Comments on IEEE 802.16j Path-loss Models in IEEE802.16j-06/013

C802.16j-06/113

IEEE 802.16j-06/013

Propose modifications on channel models in baseline document

Example of path loss curves

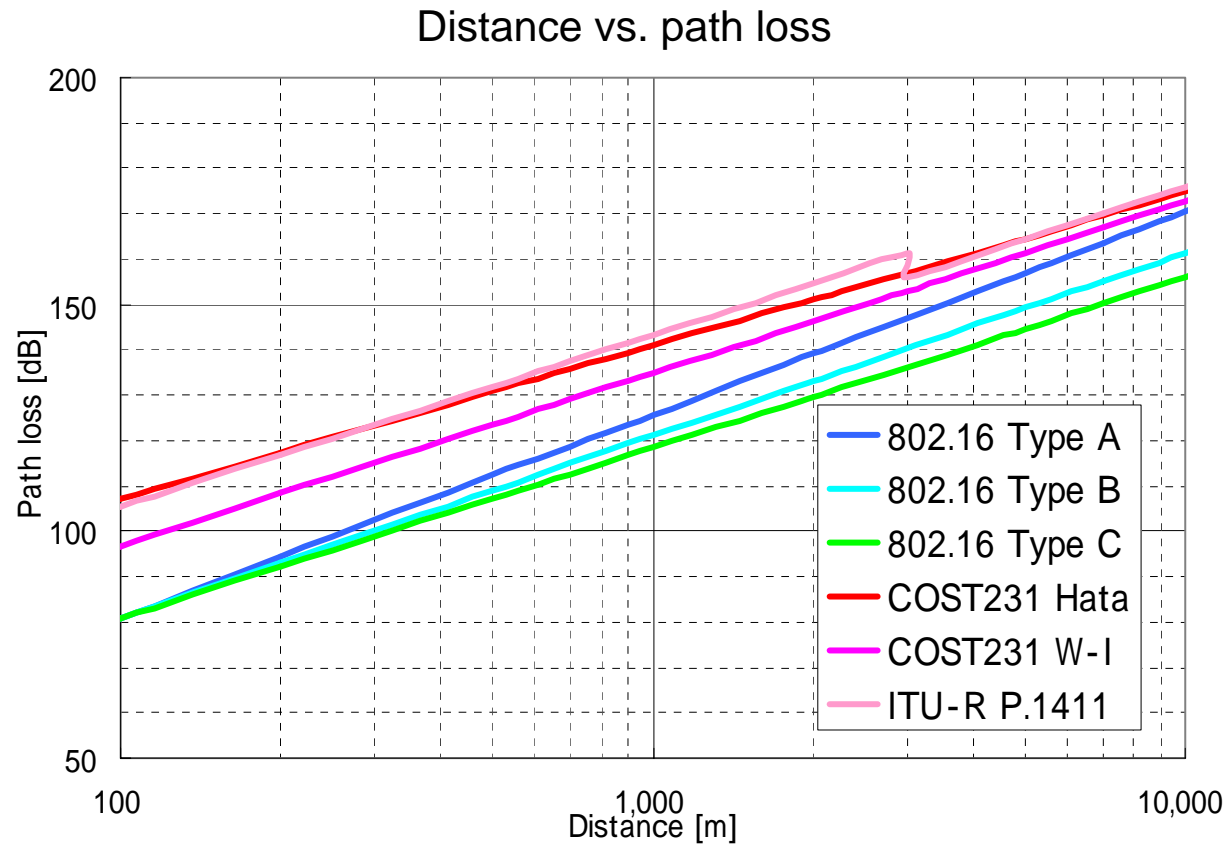
- Categories in baseline document lacks urban/suburban mobile propagation model such as COST231 Walfisch-Ikegami model, COST231 Hata model or ITU-R P.1411 for BS-MS.
- Urban mobile propagation model will be required for MMR performance evaluations
 - Urban mobile propagation model has generally larger path loss compared to models for FWA (IEEE 802.16 models)
